Product/Process Change Notice (PCN)

PCN#: PCN_WS-TASL_WS-TATL_WS-RPTL_Plating_change_2014-12-23

Product Affected: WS-TASL, WS-TATL, WS-RPTL

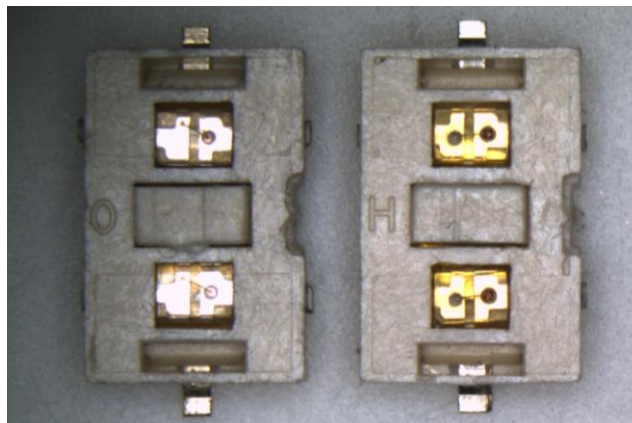
For enhancing the product reliability, Würth Elektronik changes the plating of the LED lead frame. No electrical parameters are affected by the change.

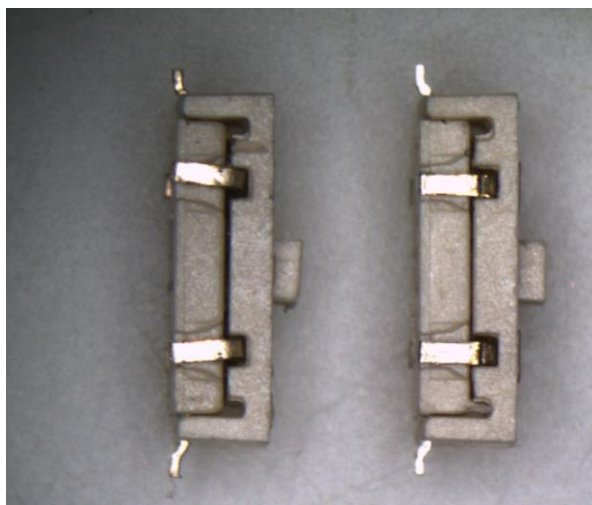
Tin plated terminal replaces silver plated terminal to improve solderability. Selective gold plating is utilized to enhance the wire bonding strength. The appearance of the LED becomes yellow.

BEFORE (LEFT):

AFTER (RIGHT):

BEFORE (LEFT):

AFTER (RIGHT):
